# Advanced Stop Lines

Cambridge Cycling Campaign  
P.O. Box 204, Cambridge CB4 3FN

Document No. N9815  
July 1998

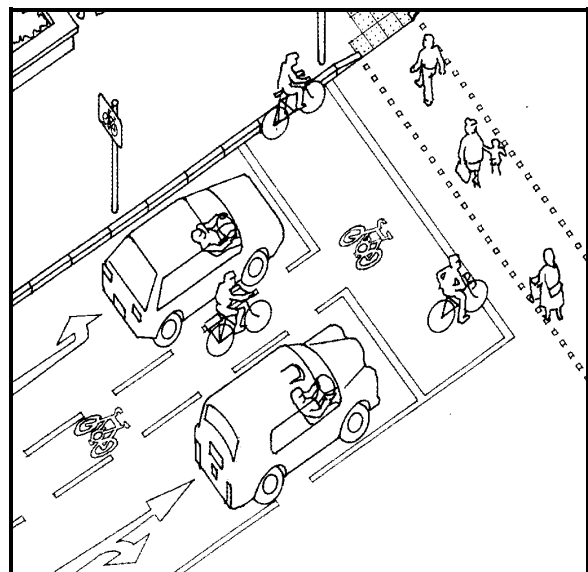
Where full-width reservoirs have been provided they work perfectly well. Cyclists are quite capable of choosing the correct position to wait. Observation of Gonville Place, where the reservoir spans two traffic lanes, shows that left-turning cyclists wait in front of the left lane and right-turning cyclists wait in front of the right lane.
